Council Reference: DA21/0233 LN 41917  
Your Reference: SSD-10398

**Tweed Shire Council Submission – Hanson Tweed Sand Plant Expansion -  
State Significant Development (SSD-10398)**

I refer to the Department's request for Council's advice / comment on the Environmental Impact Statement (EIS) for the Hanson Tweed Sand Plant Expansion (SSD-10398). Council officers have undertaken a review of the proponent's EIS and supporting documentation and provide the following comments for the Department's consideration.

**Figure 1 – Low flow (blue) / High flow (red)**

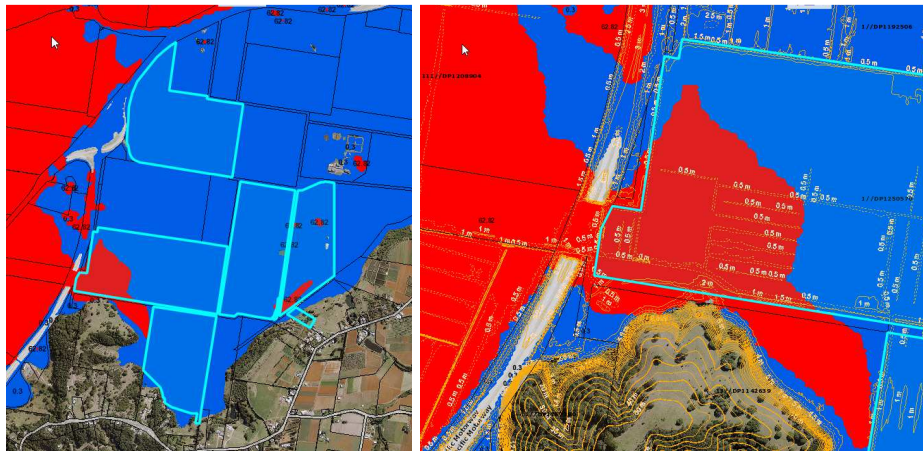
The majority of the site is classified as 'low flow' area. The exception to this is a small area in the south-west corner around the Pacific Motorway culvert/bridge (shown in red in Figure 1 below). In this area existing ground levels are as low as RL 0.5m AHD.

The proponent's FSA suggests that the proposed lake is to be bunded to RL 1.3m AHD. This will result in a bund approximately 0.8m high being placed directly downstream of the highway culverts. It should be noted this is a flow path of critical importance. It is the primary access to the wider Chinderah/Kingscliff flood storage. Any obstruction to flow here is likely to have significant impacts upstream.

Council does not agree with the above statement. Whilst this may be valid for some areas of the proposed lake expansion (where existing topography is already around RL 1.3m AHD) it is not true of the critical high flow area adjacent to the Pacific Motorway culvert/bridge. An 800mm high bund in this area is likely to pose a significant barrier to flood waters entering the Chinderah/Kingscliff storage area and therefore have significant afflux upstream.

It should be noted that DCP-A3 only permits changes to ground levels up to 300mm in high flow areas (for local drainage purposes). In this case, given the critical nature of the flow path, 300mm would not be automatically considered permissible and this would be subject to detailed flood modelling (with bunding included). Any significant bunding in this area is contrary to DCP-A3 and unlikely to be supported. **This is a significant constraint for the proposal that has not been addressed and may have substantial implications as the ability to bund the lake to RL 1.3m AHD may not be possible.** Refer to request for further information below (Item 8.1).

- a. The proposed Southern lake is to be bunded to RL 1.3m AHD. The proponent's Flooding and Stormwater Assessment does not include this bunding in its flood model as it 'is considered negligible due to its low level compared to the overall flood levels experienced at the site'. The proposal will result in a bund approximately 0.8m high being placed directly downstream of the Pacific Highway Bridge which is a critical flow path for water entering the Chinderah/Kingscliff floodplain storage. Any obstruction to flow here is likely to have significant impacts upstream.

It should also be noted that the area near the Pacific Highway Bridge is classified as "High Flow". Tweed Shire Development Control Plan section A3 – Development of Flood Liable Land strictly limits changes to ground levels in high flow areas in order to maintain flood conveyance in critical areas. Any significant bunding in this area is contrary to DCP-A3 and unlikely to be supported. This constraint has not been addressed and a proper assessment may reveal unacceptable flood impacts upstream that could have substantial implications for the proposal.

**Figure 2** - Example of responsive design identifying areas of high ecological value and applied 30 m buffers (shaded lime green) to be avoided, established and protected as overlaid with the BDAR Vegetation Zone mapping.

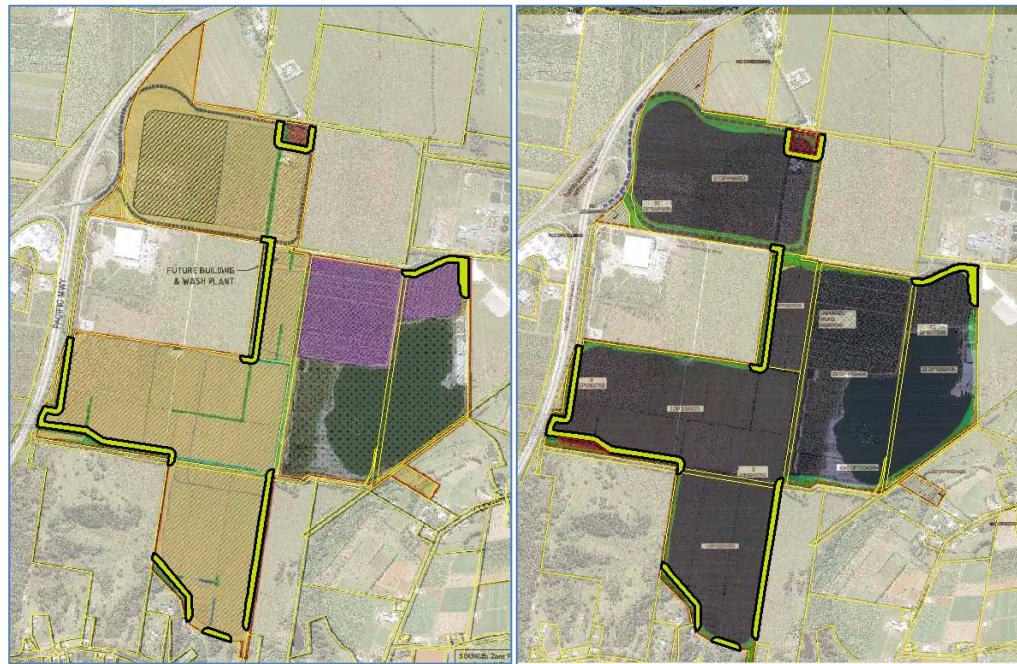
- The proposed development layout design fails to satisfy the avoid and minimise provisions set out in Section 7.2 of the Biodiversity Assessment Method 2020 prepared under the *Biodiversity Conservation Act 2016* resulting in a direct loss of 3.66 ha of remnant mapped vegetation;

- The proposed development layout design fails to satisfy the avoid and minimise provisions set out in the Tweed Development Control Plan Section A19 Biodiversity & Habitat Management resulting in a direct loss of 3.66 ha of remnant mapped vegetation and likely indirect habitat impact by virtue of inadequate ecological setbacks to red flagged values. Opportunities to retain existing vegetation and provide buffers (of minimum 30m width) are highlighted in Figures 2 and 3 below. It is noted that 50m buffers to sensitive high value, poorly represented coastal values is considered appropriate and achievable given the scale of the proposal;

- a. The development layout should be modified to demonstrate how the avoid and minimise principles/provisions specified in the Biodiversity Assessment Method 2020 and Council's Development Control Plan Section A19 Biodiversity & Habitat Management are to be met.

- b. Areas of high ecological significance (i.e. Endangered Ecological Communities, Preferred Koala Habitat) identified in the Biodiversity Development Assessment Report (BDAR) dated March 2021 prepared by JWA Ecological Consultants should be retained and afforded ecological buffers of minimum 30 – 50 metre widths to avoid adverse indirect impact. Those values and associated buffers should be the subject of a habitat restoration program, incorporated into the Concept Rehabilitation & Landscape Management Plan and afforded long term statutory protection.
